Access Compliance Report Public Rights-of-Way (Curb Ramps)

Main Street: LARKSTONE_DR Cross Street: DUNAS_RD Location: NW

ADA ID: RPAT211005091633 Ramp Type: Type 1 - Perpendicular Diagonal Initial Pass/Fail: Pass Overall Compliance: No Severity Score: 22

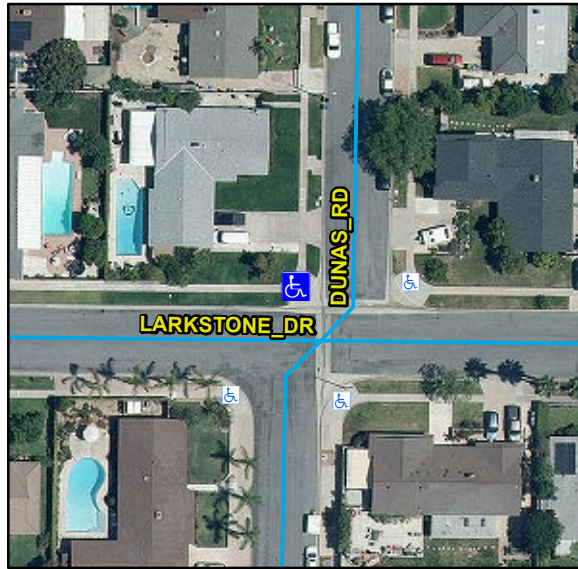
Compliance	Description	Data	Compliance	Description	Data
N/A	Ramp Length (in)	136	N/A	Flare Type LT	
Yes	Ramp Width (in)	54			Sloped
Yes	Ramp Run Slope (%)	6.8	N/A	Flare Slope LT (%)	5.1
Yes	Ramp Cross Slope (%)	1.2	N/A	Flare Traversable LT	No
N/A	Landing Present	No	N/A	Flare Type RT	
N/A	Landing Length (in)	N/A			Sloped
No	Landing Width (in)	N/A	N/A	Flare Slope RT (%)	4.9
No	Landing Run Slope (%)	N/A	N/A	Flare Traversable RT	No
No	Landing Cross Slope (%)	N/A	No	DWS Provided	No
N/A	Landing Movement Obstructed?	No	N/A	DWS Contrast	N/A
	Landing Movement Type	N/A	N/A	DWS Length (in)	N/A
N/A	Landing Shared	N/A	N/A	DWS Full Width	N/A
N/A	Clear Space	Yes	N/A	DWS Offset Left (in)	N/A
N/A	Clear Space To Crosswalk (in)	48	N/A	DWS Offset Right (in)	N/A
N/A	Marked Crosswalk 1	No	N/A	Marked Crosswalk 2	No
	Crossing 1 Direction	S		Crossing 2 Direction	E
	Marked Crosswalk 1 Width (in)	N/A		Marked Crosswalk 2 Width (in)	N/A

N/A	Ramp Inside Crosswalk 1	N/A	Yes	Ramp Inside Crosswalk 2	N/A
	Crossing 1 Slope (%)	2.5		Crossing 2 Slope (%)	2.4
	Crossing 1 Cross Slope (%)	1		Crossing 2 Cross Slope (%)	2.6
Yes	Gutter Ponding	No	No	Curb Slope	6.4
Yes	Gutter Lip Height (in)	0		Road Run Slope (%)	0.8
Yes	Gutter Run Slope (%)	2.7		Road Cross Slope (%)	2.8
Yes	Gutter Cross Slope (%)	1.6			
Yes	Overall Surface Condition: Acceptable		No	Perp Joint Present	No
	Cross Gutter Present?	Yes		Spandrel Present?	Yes
	Replace Cross Gutter?	No		Replace Spandrel?	No

Remove & Replace Curb Ramp With Two New Directional Ramps or Equivalent.
